Technical Bulletin

ICOM

IC-R71/R71AJ

GENERAL COVERAGE RECEIVER
GJ36783

PLL Board

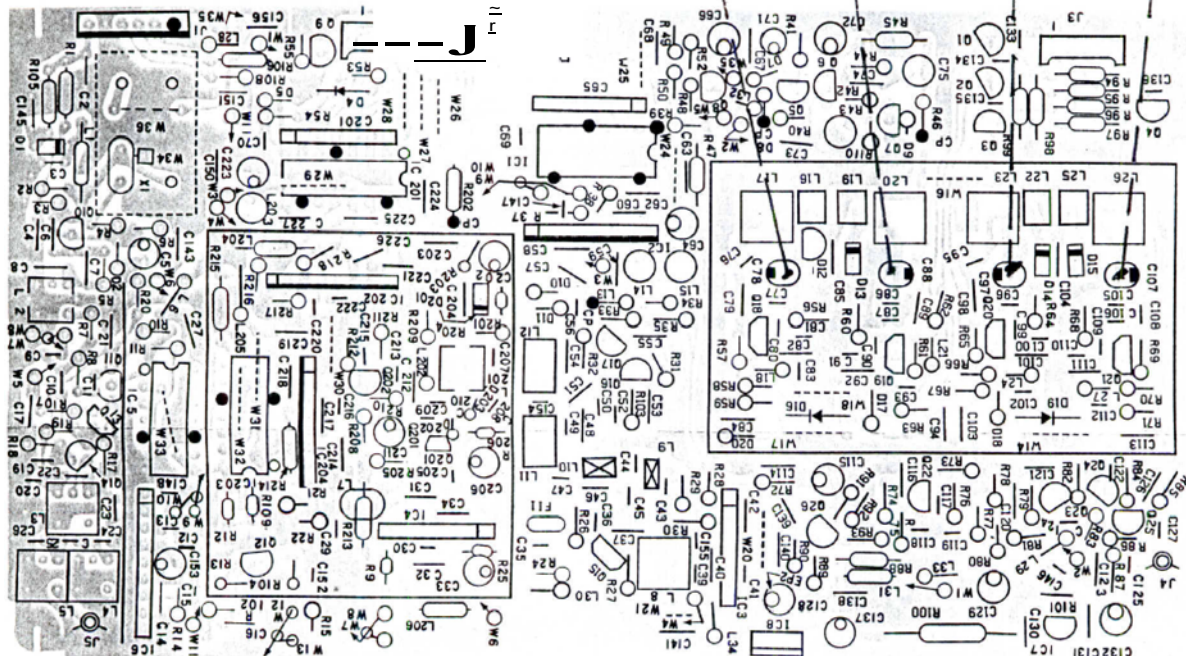
Distorted receive and/or transmit audio on one or more bands. Audio may cut out completely. Distortion may be temperature related. Single sideband audio sounds "raspy" or "rough". Selected frequency may show instability.

The trimmer caps in the PL unit may have aged and changed values.

Replace the following trimmer caps:

C78	10pf	with an Icom # 4610000110 12pf unit VCO cap (white)
C88	10pf	with an Icom # 4610000110 12pf unit VCO cap (white)
C97	6pf	with an Icom # 4610000100 6pf unit VCO cap (red)
CI07	6pf	with an Icom # 4610000100 6pf unit VCO cap (red)

We recommend that you remove the excessive sealing wax from around replacement trimmer caps to prevent future contamination. We also recommend that you check the REG unit circuit board for cracked or cold solder joints. The circuit is adjacent to the PL unit.

The replacement trimmer caps are long-life ceramics. A partial realignment is required after these trimmers are replaced. See Service Manual for procedure.
